# Technical note: BFARe alignment review

This technical note compares EWR Co's preferred alignment which would approach the Bedford area from the north with BFARe's proposed alternative which would approach Bedford from the south, as set out in their response to the 2019 and 2021 non statutory consultations.

Figure 1- Map showing EWR Co's preferred route alignment 1 (Tempsford variant) and version 1 and version 2 of BFAre's alternative alignments against local environmental consideration.

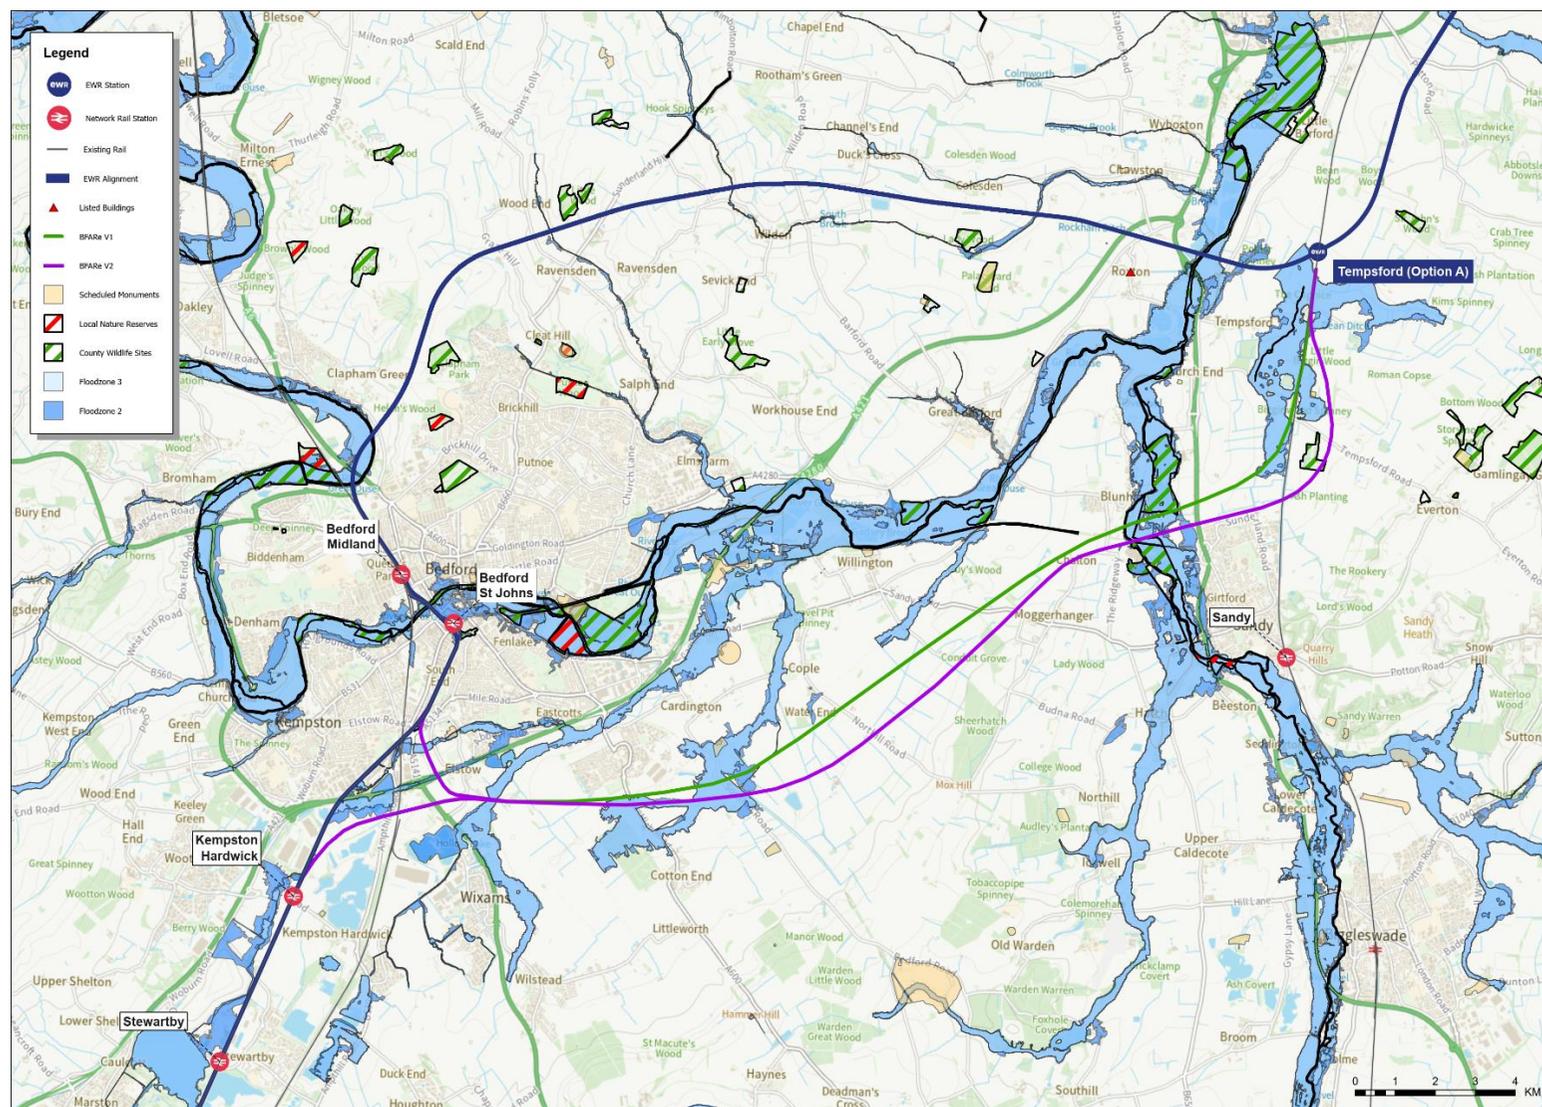
- 1.2.4 BFARe set out their proposed alternative to alignments proposed in the NSC 2021 for a route between Bedford and St Neots Station in the North Bedfordshire elected representatives' forum 23 November 2021, as version 2. Version 1 of their alignment is shown as a green line and version 2 is shown as a purple line in Figure 1. The key difference between the two alignments is that the latter was amended to avoid constraints in the Cardington, Cople and Willington areas.

- 1.2.5 Importantly, the BFARe Alignment (considered to be version 2 of the alignment) is broadly similar to the alignment considered as part of an alignment feasibility study developed to support the environmental analysis undertaken in 2019 to inform PROA. The environmental analysis was a key consideration in the decision-making process for PROA. The developed 'representative' alignments for each Route Option allowed a fuller and more accurate analysis of costs, environmental impacts and opportunities amongst other factors to support the PROA.

- 1.2.6 Figure 1 shows EWR's Co's preferred route alignment 1(Tempsford Variant) as a navy blue line (following the [Route Update Announcement in 2023](#)) and version 1 and version 2 of BFARe's proposed alignment.
